CHANGE NOTICE

Effective Date: JANUARY 1, 2011
Log Number: CN-1-425
Subject: DRAIN VALVE, PN 04113.00
Model Affected: L-1X, L-1X16, 180UC

DRAIN VALVE PN 04113.00

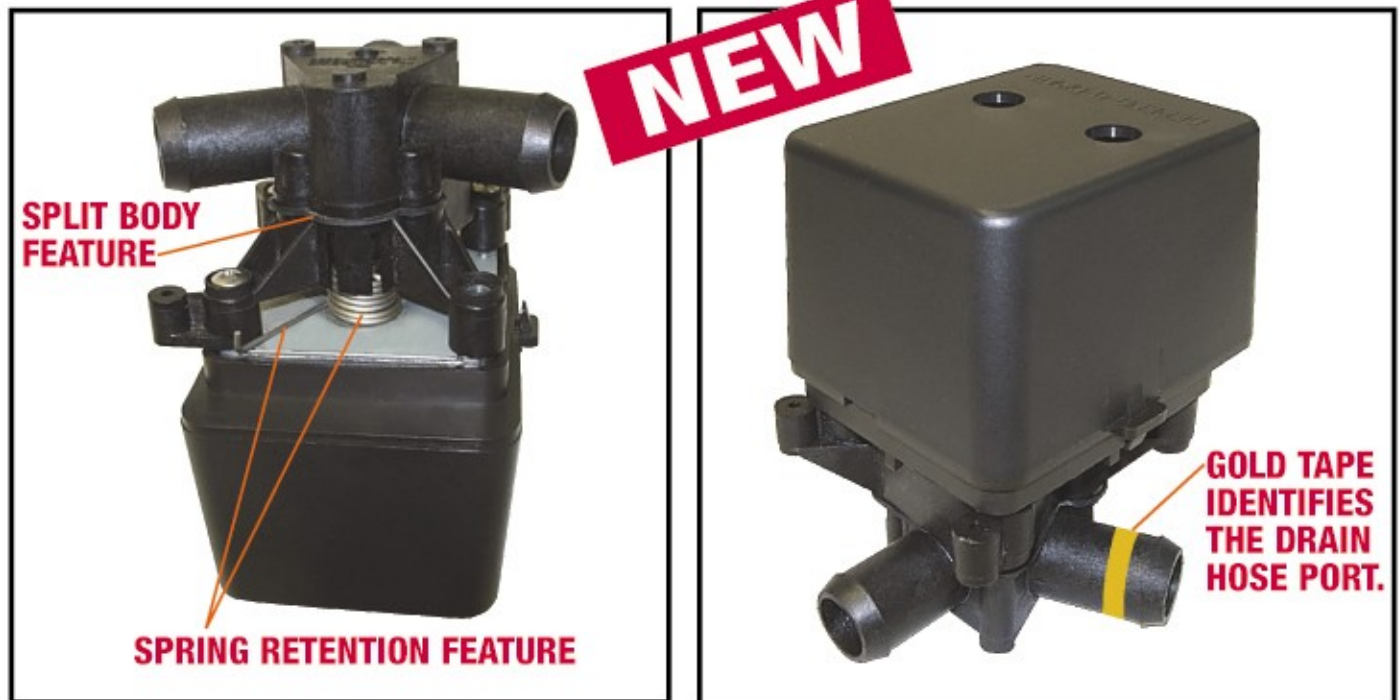
The 3-way drain valve, PN 04113.00, has had a couple of small but important engineering improvements. The body of the valve has been changed to incorporate a spring retention feature. When servicing the flipper valve seal, the spring is held in loaded position while reassembling the valve. The old system required one hand to hold the loaded spring while trying to assemble the valve port to the motor assembly. The valve assembly has a “split body feature” that simplifies the servicing of the hinge seal.
